05.1-32

Recall R691 –
Incorrect Emission Control Label –
Install Revised Label – U.S. Vehicles

MODEL 1995 MY XJR
VIN 720001-754303

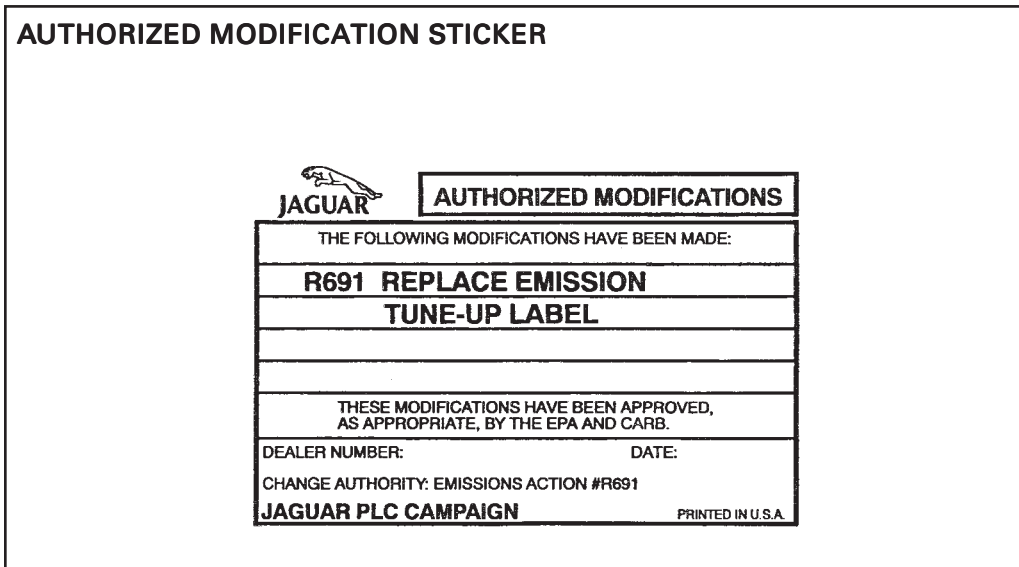
On all 1995 Model Year XJR Sedan Models within the above VIN range, the factory-installed Emission Control Data Label ("Tune-up Label") was incorrectly specified. This label is applied to the crossmember above the radiator, within the engine compartment. 1995 MY XJ6 4.0L Sedan models with naturally-aspirated AJ16 engines are NOT affected.

The existing label implies that the engine is equipped with an Exhaust Gas Recirculation system which is not the case.

Jaguar Cars will contact customers by mail. The necessary replacement labels for this purpose, bearing the correct wording, will be supplied to you by Jaguar Cars.

ILLUSTRATION 2

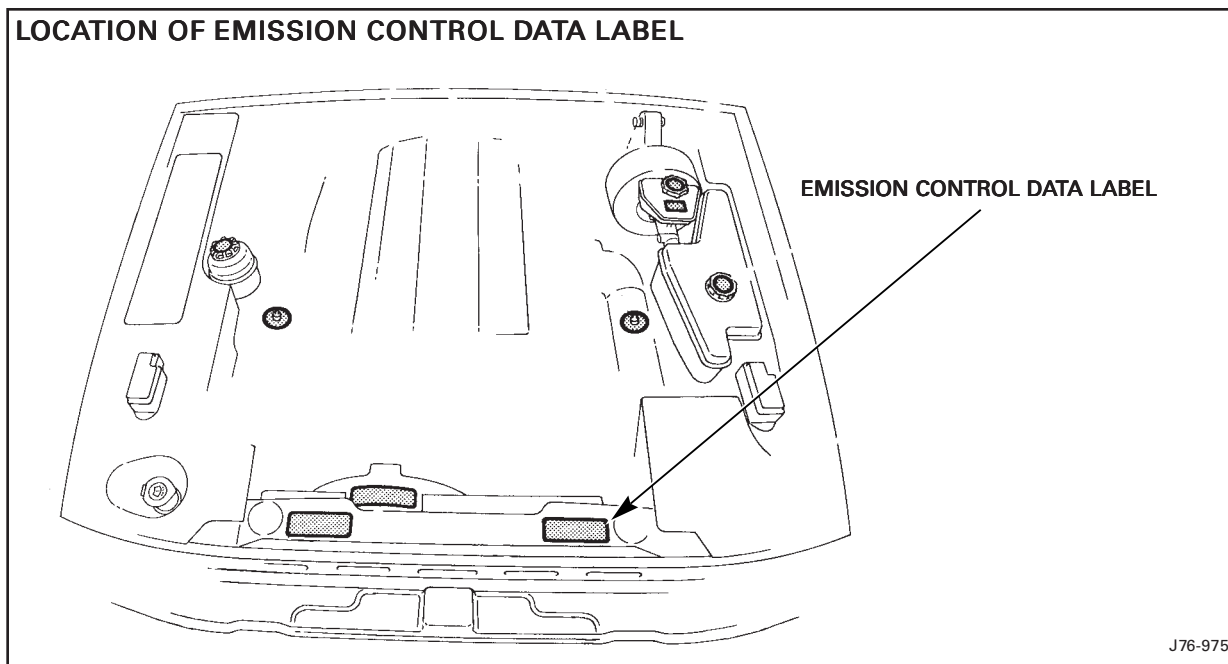
LOCATION OF EMISSION CONTROL DATA LABEL

2. Identify the Emission Control Data Label (“Tune-up Label”), located on the left side of the cross panel above the radiator (Illustration 2).
3. Clean off the existing label.
4. Apply the replacement label over the old label.
5. Apply an R691 authorized modification label to the Driver side B-pillar. (This label will immediately indicate to any other Dealer that the vehicle concerned has already been rectified).
